CODE COMPLIANCE CERTIFICATE Section 43(3), Building Act 1991

Project Descrn: NEW CONSTRUCTION
BEING STAGE 1 OF AN INTENDED 1 STAGES
SHOWHOME/DWELLING (ON LOT 6)

Project Location: 52 KAKARIKI GR WAIKANAE

SECTION C-C SCALE 1:50

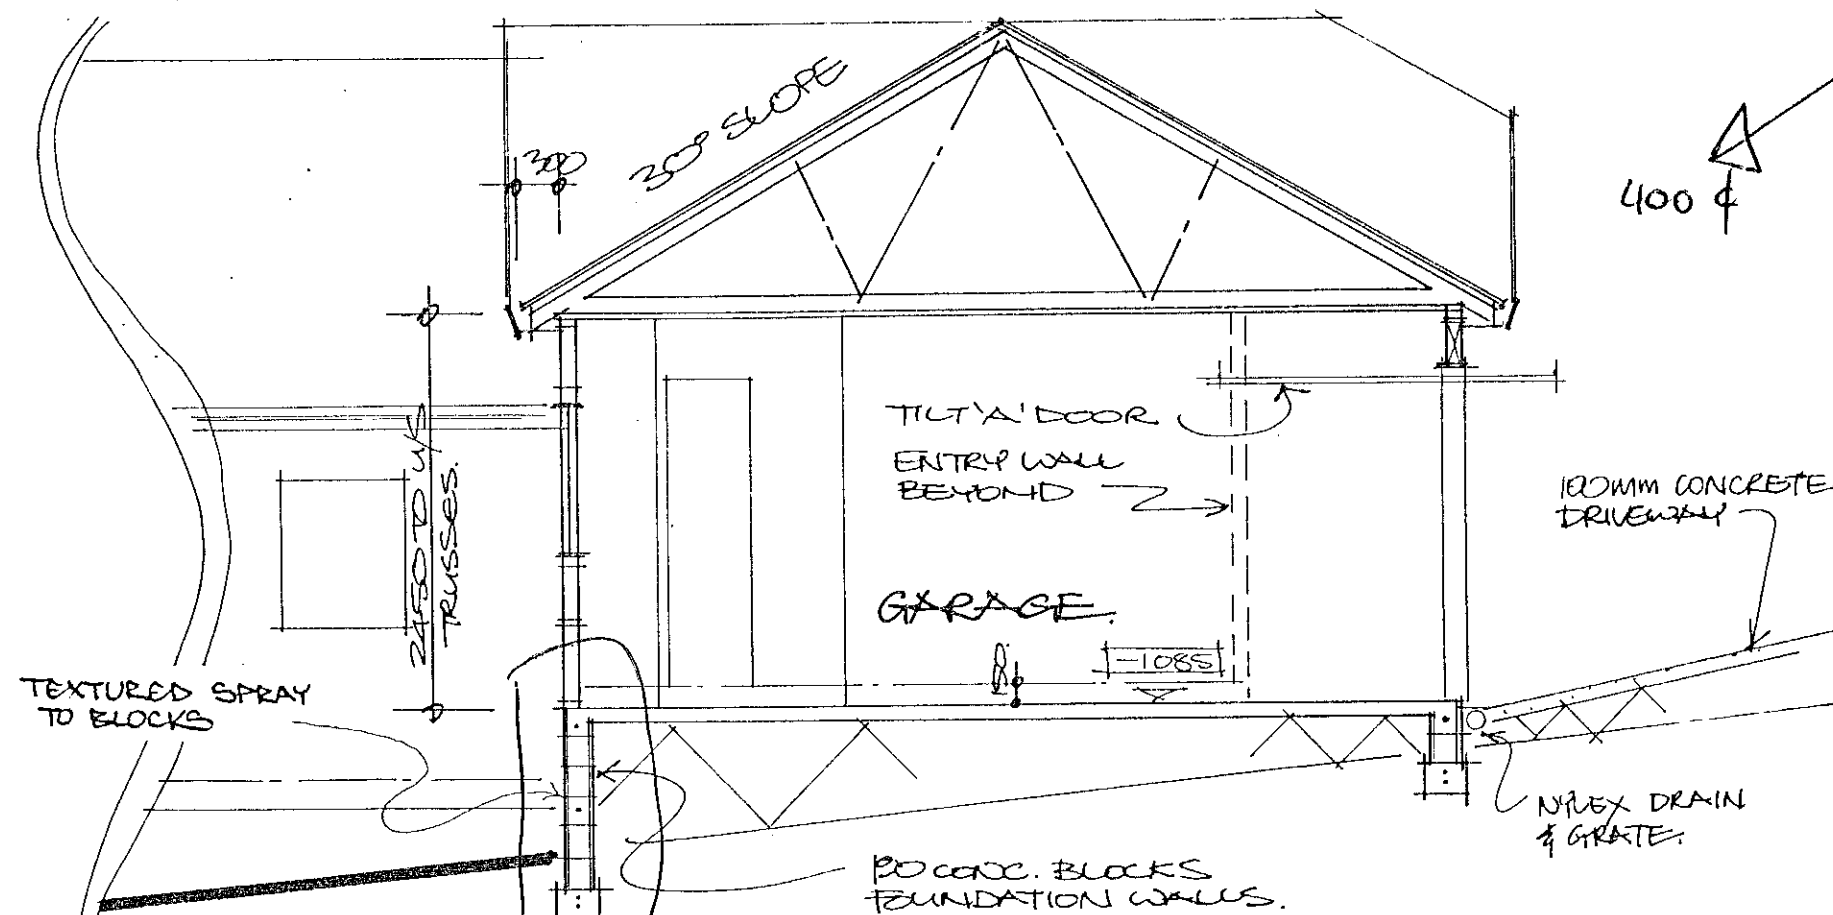
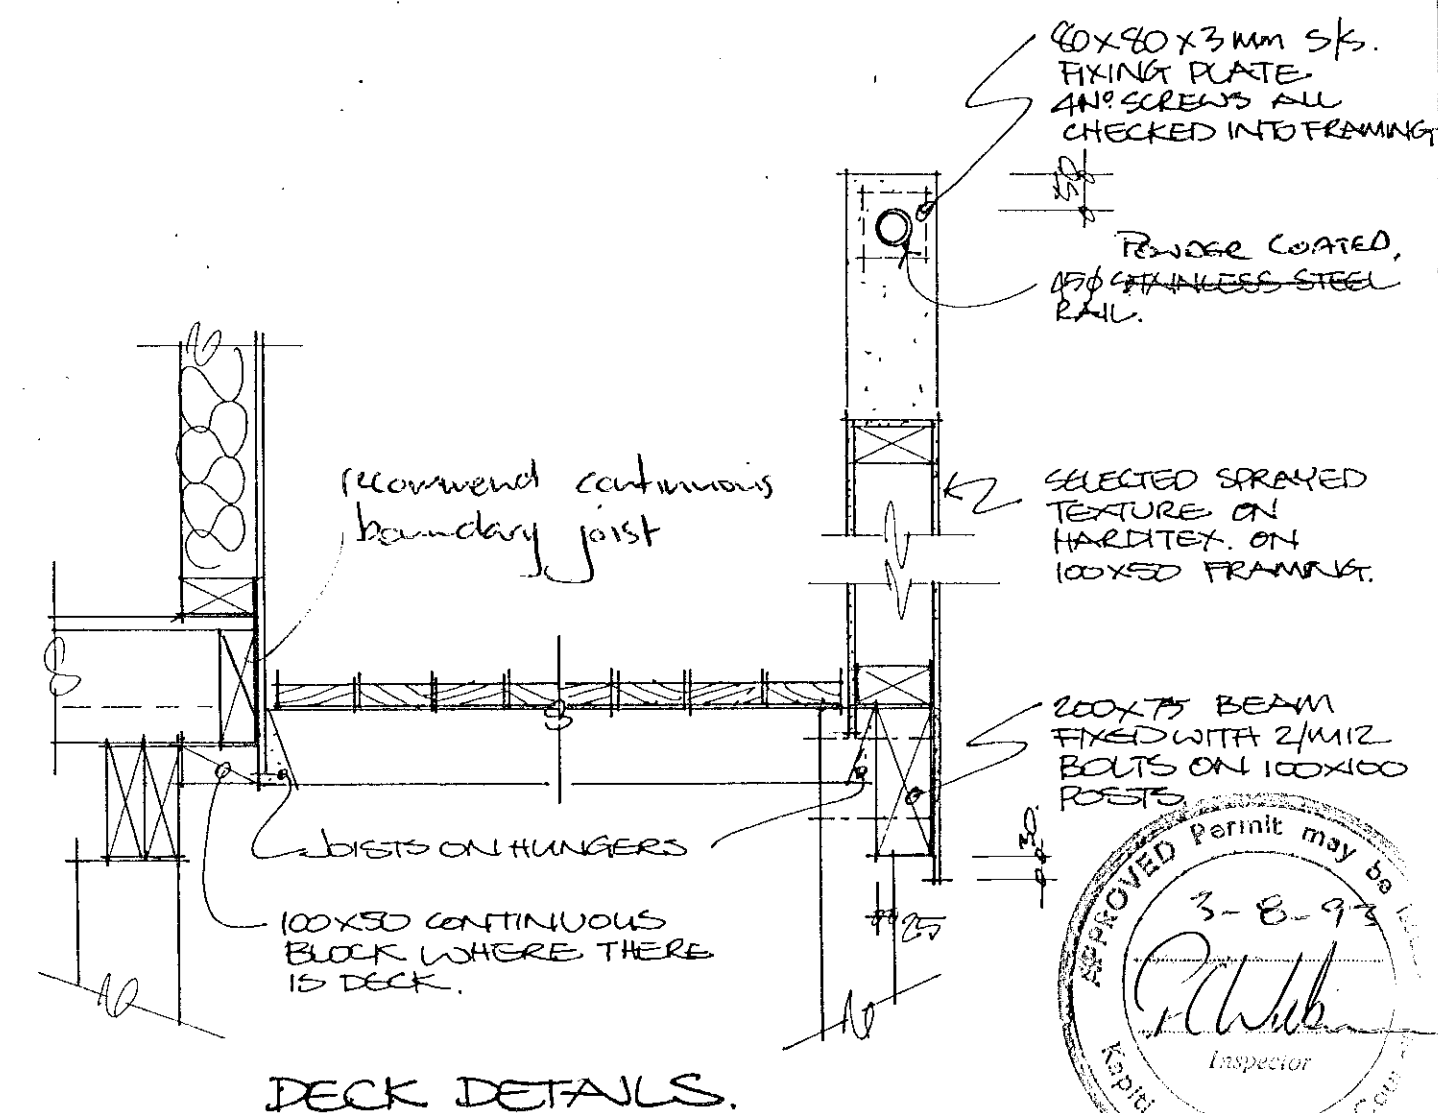
Vertical reinforcing to be D12's @ 400cs this face and returning 1.5 metres down each side wall.
 Otherwise as detailed Sheet.4 OK.
